**True Wireless Headphones  
RZ-S500W / RZ-S300W**

## **Panasonic Releases Firmware Update for the RZ-S500W and RZ-S300W**

### List of touch sensor controls

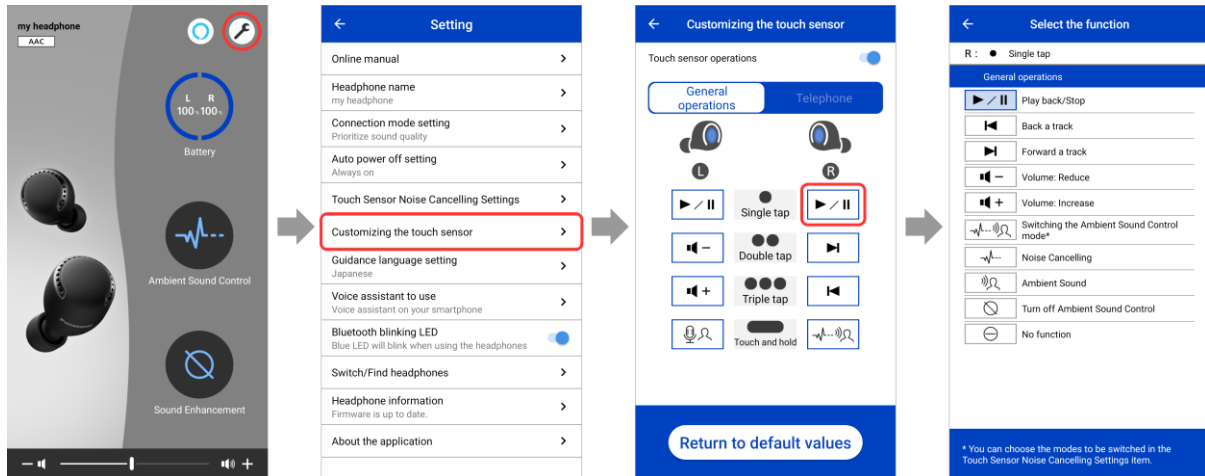
## Added touch sensor customization option

Users can now customize the controls for the left and right touch sensors through the application.

### Sound collection

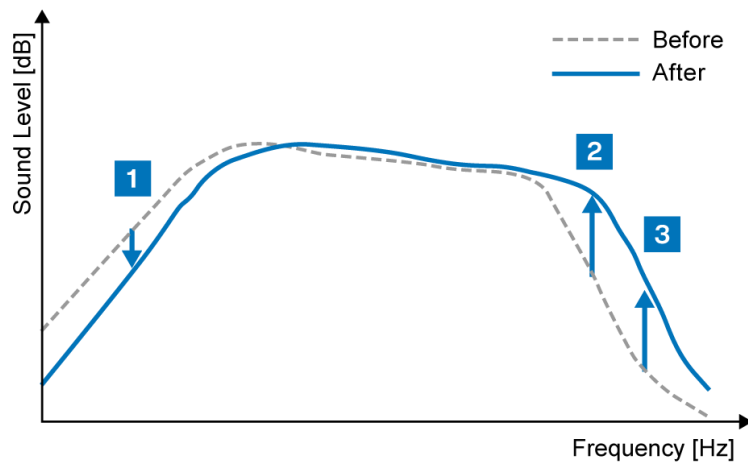
## Improved voice transmission quality during phone calls

During phone calls, users' voices are transmitted even more clearly than before to the other end of the line.

- (1) Reduced clipping and distortion with low-pitched voices.
- (2) Voices have been made clearer, with sound reproduction close to the speaker's actual voice.
- (3) Even high-pitched whispers have been made clearer, with sound reproduction close to the speaker's actual voice.

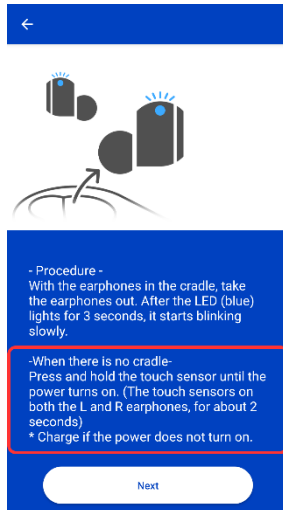
## **Added explanation of how to wake up the headphones from the “auto power off” mode**

Users can now see how to wake up the headphones from the "auto power off" setting through the application.

Hold down both the left and right touch sensors until the LED light turns on (approx. 2 seconds). If the headphones do not turn on, please ensure they are fully charged.
